Access Compliance Report

Public Rights-of-Way

(Curb Ramps)

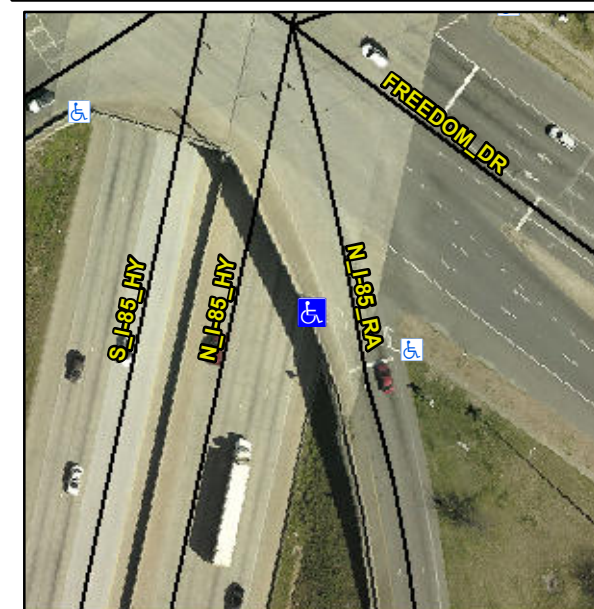
Intersection ID: 9734	Main Street: FREEDOM_DR	Cross Street: S_I-85_HY	Location: W
ADA ID: F49C5752C367	Ramp Type: Perp	Initial Pass/Fail: Fail	Overall Compliance: No
Severity Score: 21.25			
Codes/Mitigation Info/Possible Solution		Field Measurements/Component Compliance

PROW/ADA:

R304.5.1, R304.2.2

Compliance	Description	Data	Compliance	Description	Data
N/A	Ramp Length (in)	84.0	No	Ramp Slope (%)	10.7
No	Ramp Width (in)	47.0	Yes	Ramp XSlope (%)	0.9
N/A	Flare Type LT	N/A	N/A	Flare Type RT	N/A
N/A	Flare Slope LT (%)	N/A	N/A	Flare Slope RT (%)	N/A
N/A	Flare Traversable LT?	N/A	N/A	Flare Traversable RT?	N/A
N/A	Landing Length (in)	N/A	N/A	DWS Provided?	N/A
N/A	Landing Width (in)	N/A	N/A	DWS Contrast?	N/A
N/A	Landing Slope (%)	N/A	N/A	DWS Length (in)	N/A
N/A	Landing X Slope (%)	N/A	N/A	DWS Full Width?	N/A
N/A	Landing Curb? (Y/N)	N/A	N/A	DWS Offset (in)	N/A
N/A	Shared Landing?	N/A			
N/A	Gutter Ponding?	N/A	N/A	Gutter Slope (%)	N/A
N/A	Gutter Lip Ht (in)	N/A	N/A	Gutter X Slope (%)	N/A
N/A	Painted X Walk1?	Yes	N/A	Painted X Walk2?	N/A
	X Walk 1 Direction	To SE		X Walk 2 Direction	N/A
N/A	X Walk 1 Width (in)	103.0	N/A	X Walk 2 Width (in)	N/A
	X Walk 1 Slope (%)	0.2		X Walk 2 Slope (%)	N/A
	X Walk 1 X Slope (%)	1.3		X Walk 2 X Slope (%)	N/A

Possible Solutions:

Remove & Replace Entire Ramp.
